Docket Number:	19-SPPE-03
Project Title:	Sequoia Data Center
TN #:	232270
Document Title:	Testimony of Robert Sarvey on the Initial Study MND for the Sequoia Data Center
Description:	N/A
Filer:	Robert Sarvey
Organization:	Robert Sarvey
Submitter Role:	Intervenor
Submission Date:	2/28/2020 4:15:42 PM
Docketed Date:	2/28/2020

Sequoia Data Center

Robert Sarvey's Testimony on the Sequoia Data Center IS/MND

TABLE 5.3-8 SEQUOIA MAXIMUM IMPACTS DURING READINESS TESTING AND MAINTENANCE-TESTING ONLY (µg/m³)

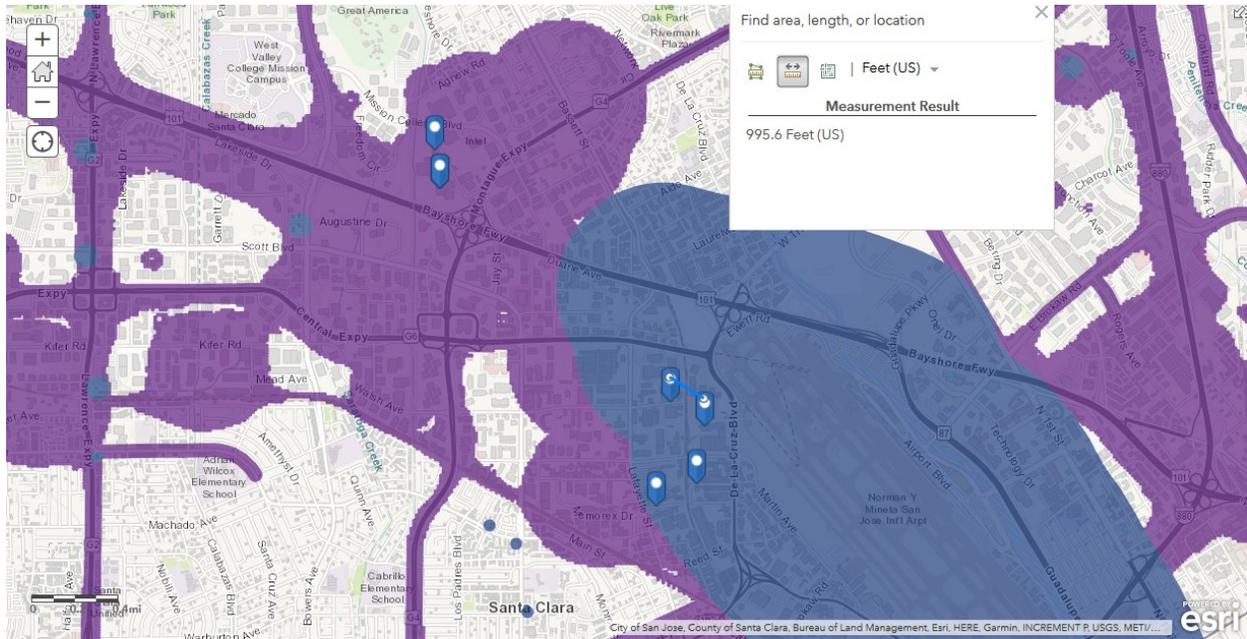
SDC Commission Staff did model the testing and maintenance of one diesel generator at a time in the ISA/MND. The results presented below show that with just one generator operating the projects impact plus background is within 1 % of the Federal 1-hour NO₂ standard and within 2% of the State 1-hour NO₂ standard.

If operating only one generator at a time almost exceeds the State and Federal NO₂ standards emergency operation will surely exceed both standards which would be a significant impact under CEQA requiring mitigation. Without modeling emergency operation, the applicant cannot bear the burden of proof that the project will not violate State and Federal NO₂ standards. The project can reduce its NO₂ impact by utilizing

natural gas IC engines or fuel cells or Tier 4 diesel engines as Santa Clara Data Center did to reduce its NO2 impacts.

Santa Clara Data Centers Under Commission Review and Distance between SDC and Walsh Avenue DC

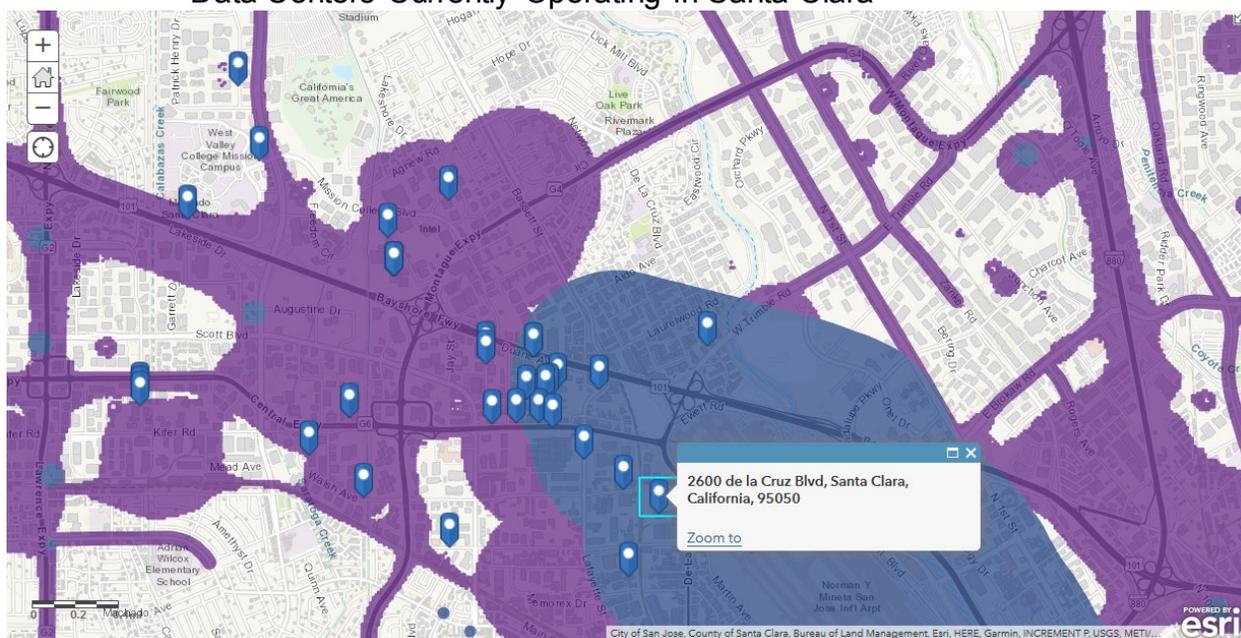
The energy commission is currently processing six other data centers including the McLaren Data Center it recently approved. The distance between the Walsh Avenue Data Center and the SDC is less than 1,000 feet.

BAAQMD has determined that the project area shaded in blue in the map above requires further study. BAAQMD Planning healthy Places handbook on page 12 describes the blue shaded project area in the map above. The handbook states,
